Office Action Summary	Application No. 10/789,268	Applicant(s) STAGER, BRADLEY R.	
	Examiner Bena Miller	Art Unit 3725

DETAILED ACTION

Claims 1, 3-5, 7, 9-11 and 17-28 are rejected under 35 U.S.C. 102(b) as being anticipated by Crammond (US Patent 5,485,873) or Bielagus et al (US Patent 5,937,923) or Swartwood et al (US Patent 5,979,522).

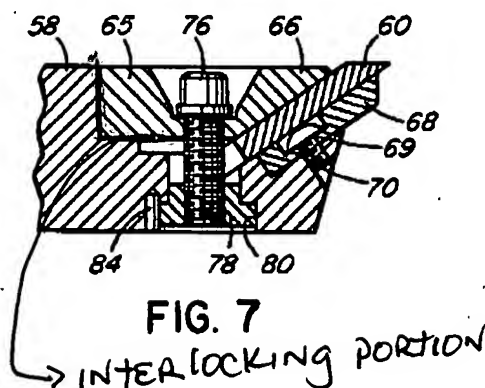
In response to applicant's remarks that Crammond fails to teach the wearshoe and base include "cooperatively interlocking portions adapted to substantially prevent movement of said base, relative to said wearshoe, in a first direction toward the knife and perpendicular to the axis of said bolt, said interlocking portions meeting so as to define an angle ϕ with respect to said first direction that is in the range 45 - 60 degrees", applicant's attention is directed to the below marked copy figure 7.

Further, in col. 5, lines 3-5 of Bielagus, member 65 is forced into contact with knife 60 and counter knife 68 via member 78 to clamp the knife package to the carrier 58. The examiner takes the position that the interlocking portion of the wearshoe and base define an angle of the specified range noted above.

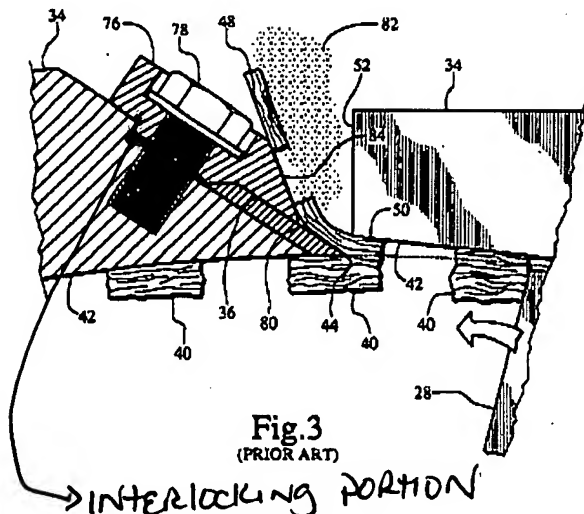
In response to applicant's remarks that Bielagus et al fail to teach an upper clamping member be "cantilevered" from the base, the examiner disagrees. Figure 3 shows clamp 76 supported by a projection surface of 34 in which the projection provides a cantilevered support for clamp 76. Bolt 78 is then used to force clamp 76 in contact with the knife. Therefore, the device of Bielagus et al, meet the claimed limitation. Further, in response to applicant's remarks that Bielagus et al fail to teach a gap between the upper clamping member and the wearshoe that is greater than the thickness of the knife, the applicant's attention is directed to the above rejection.

In response to applicant's remarks that Bielagus et al fail to teach the wearshoe and base include "cooperatively interlocking portions adapted to substantially prevent movement of said base, relative to said wearshoe, in a first direction toward the knife and perpendicular to the axis of said bolt, said interlocking portions meeting so as to define an angle ϕ with respect to said first direction that is in the range 45 - 60 degrees", applicant's attention is directed to the below marked copy figure 3.
